**RIO LINDA/ELVERTA POWER PROJECT
RESPONSES TO
CALIFORNIA ENERGY COMMISSION DATA REQUESTS
(through May 15, 2001)
(01-AFC-1)**

TECHNICAL AREA: Biological Resources

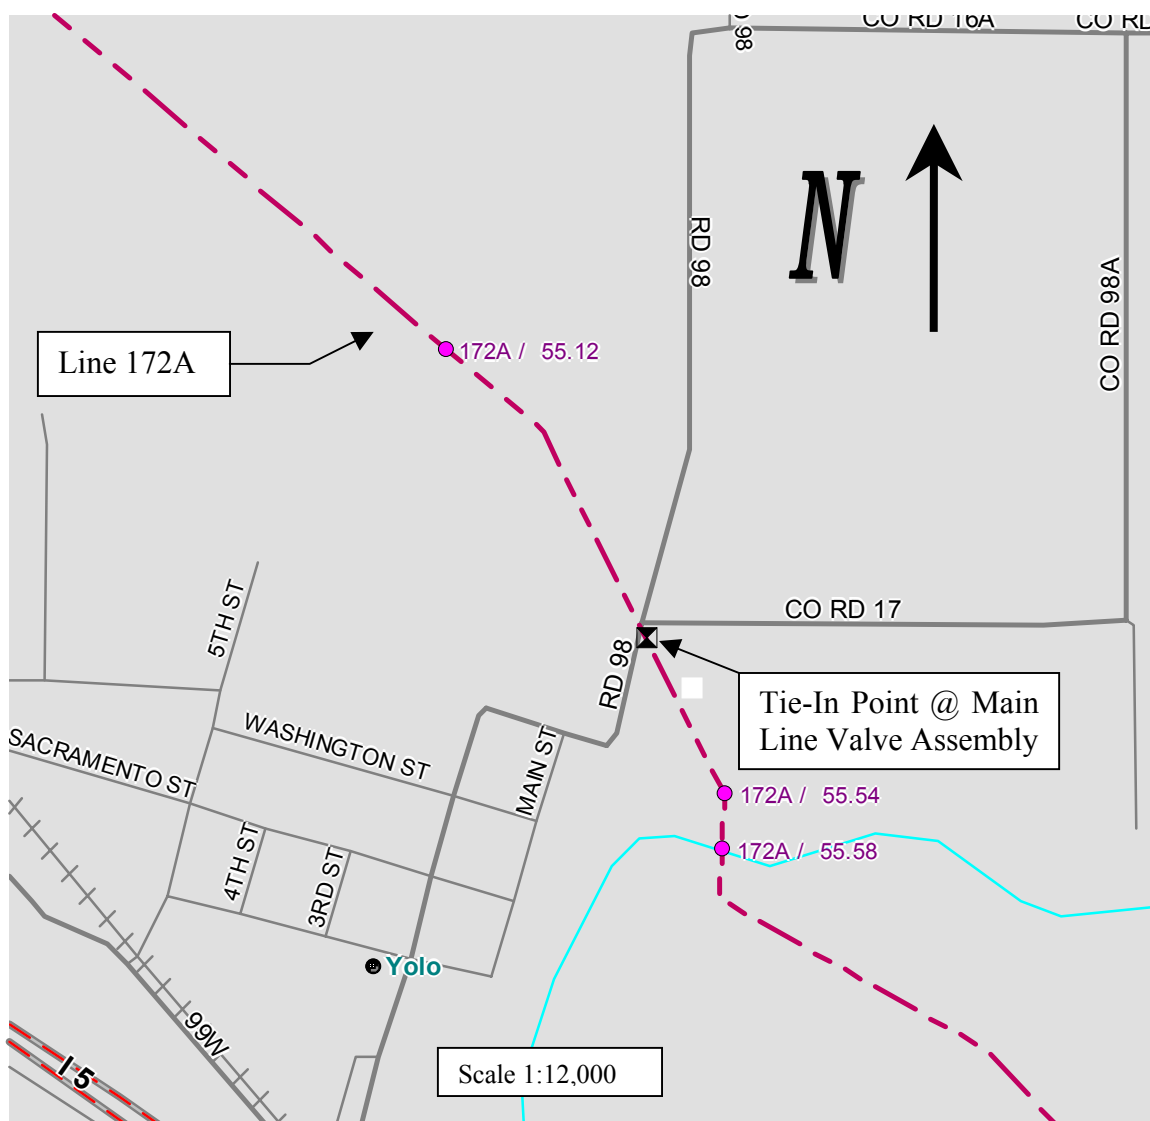
Data Request #26: Show the location of the multi-use trail easement to be granted to the Rio Linda/Elverta Parks District.

Response: The location of the multi-use trail leading to the Natomas East Main Drainage Canal will be determined after consultation with the Rio Linda Elverta Parks District as to the appropriate location of the trail, as required under Zoning Agreement 940749.
